PLUGGING CHANGES

**From:** Andrews, David  
**Sent:** Monday, May 23, 2011 10:58 AM  
**To:** 'Cramer, Roy W. (RoyCramer)'; blau@blm.gov  
**Cc:** bill\_kraft@blm.gov; Swank, Brent (BSWA); Buddy\_L\_Thompson@blm.gov; Browning, Chuck; Peterson, Diane L. (DLPE); Krabacher, Jay; Longworth, Mike; Kellerby, Shaun; STEVE HALCOMB  
**Subject:** RE: Purdy #3X-1 - P&A

## PURDY 3X1 Current Wellbore

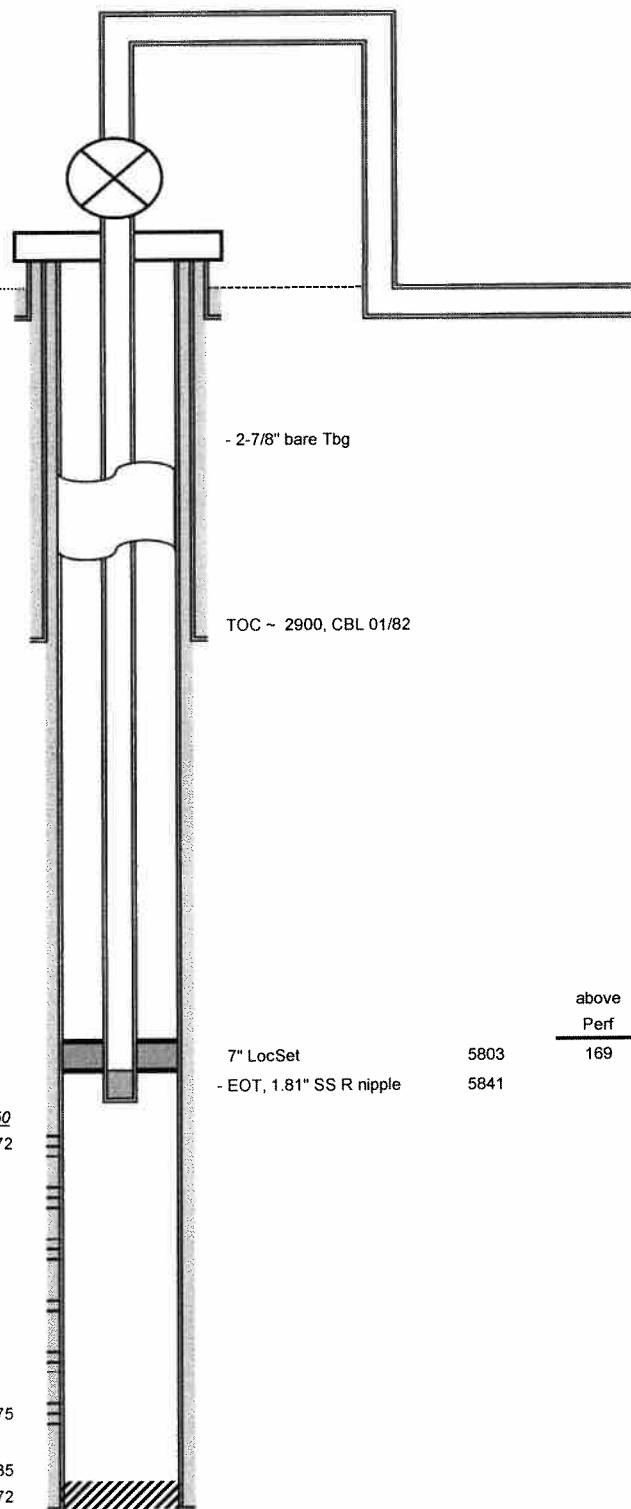
When I went through the original cement job on the 7" casing, I noted that they had cement to surface as stated below:

11/81: Set 7" Casing at 6470', pump 1500 sxs expanding cement, drop plug & displace w/ 251 bbls (cement returns to surface at 170 bbls).

08/81: Set 9-5/8" casing at 2965', pumped 450 sxs Econolite + 150 sxs G cement w/ 2% CaCl<sub>2</sub>, returned 61 bbls to pit, RIH w/ 90' of 1" pipe and topped off with 75 sxs G cement w/ 2% CaCl<sub>2</sub>.

CHANGE TO PLUGGING PROCEDURE: I scanned through the approved procedure, and I would prefer that you move your perfs up for the surface casing shoe squeeze. The surface casing shoe is at 2,965', and I would like to move the perfs from the current approved depth of 3,090' to 50' below the shoe at 3,015'. Please let me know if you have any logistical problems with this change.

COULD NOT SQUEEZE  
7" CSG CMT TO SURFACE.  
SEE 5/23/2011 EMAIL.  
D.A.

Thanks for the additional information. With cement to surface on the 7" casing, this email confirms my verbal approval of plugging changes, which I discussed with Brent Swank on the phone today. I understand that a balanced cement plug was pumped in the 7" casing across the surface casing shoe, and a balanced cement plug will be pumped in the 7" casing from approximately 60' to surface.
